Oakland City Planning Commission

Case File Number: ZP160061

STAFF REPORT

Proposal: Highrise commercial and office building Applicant: CIM Group, Sean Buran: p: (323) 860-1811

NORTH ELEVATION

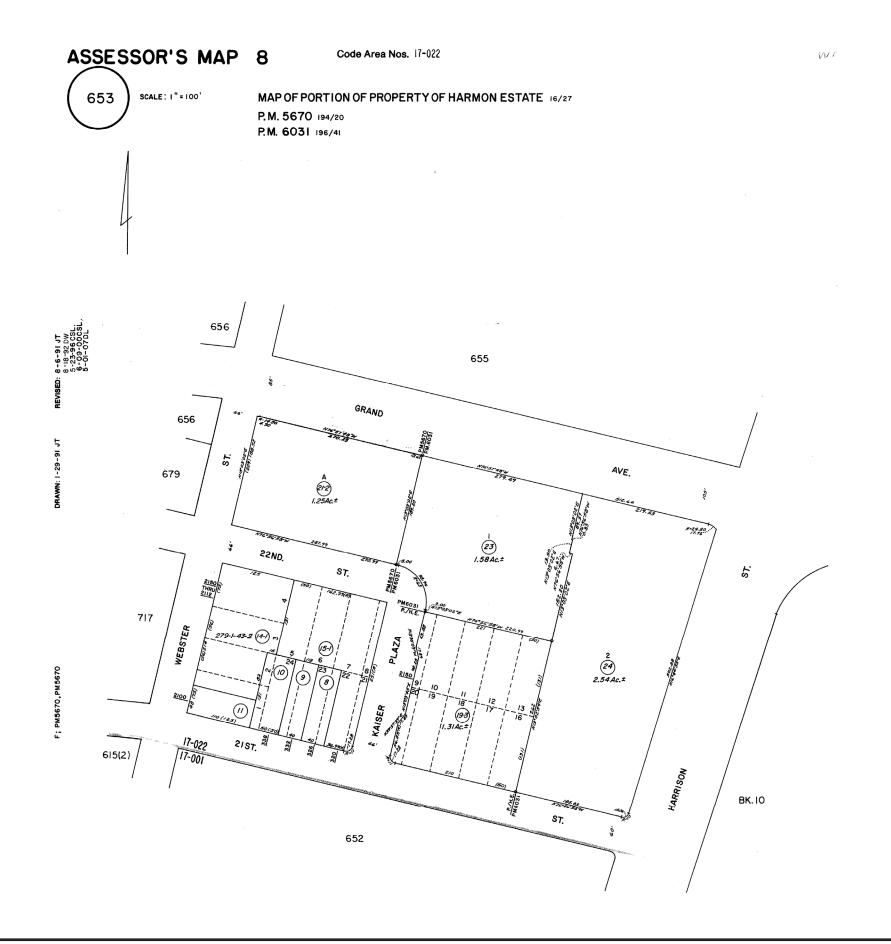
- Inactive Space: The north side of the building, facing 22nd Street, includes extensive "back-of-house" uses including a driveway to the on-site parking, an adjacent wide driveway and loading area, and utility access. This area is not activated and does not contribute to a vibrant streetscape on 22nd Street. However, staff understands that these utilitarian uses need to be located somewhere and prefers they be located away from 21st Street and Kaiser Plaza. In addition, the project does provide a retail access point at the corner of 22nd Street and Kaiser Plaza to mitigate the inactive frontage on 22nd Street.

SOUTH ELEVATION

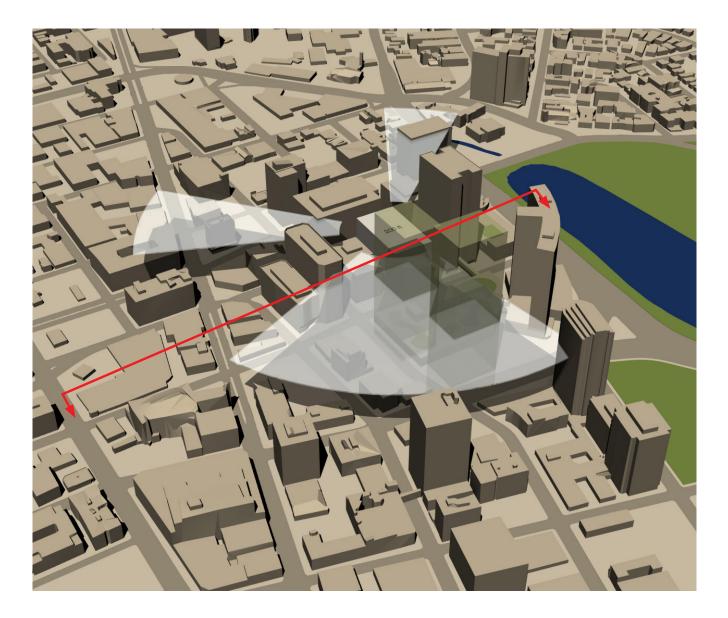
- Active Uses: It should be noted that this project has thoughtfully activated the base of the building facing 21st Street. The plans include an apron of active uses fronting the parking on the south side of the building. In addition, the first three floors are each 25 feet floor-to-floor (resulting in 75 vertical feet of active space). This results in extensive bright, light, activated space supporting the vibrancy of the street level. The primary building entrance includes generous transparency and openness and includes a groundplane scheme that extends from within the building into the sidewalk. In general, the 21st Street frontage is very successful.
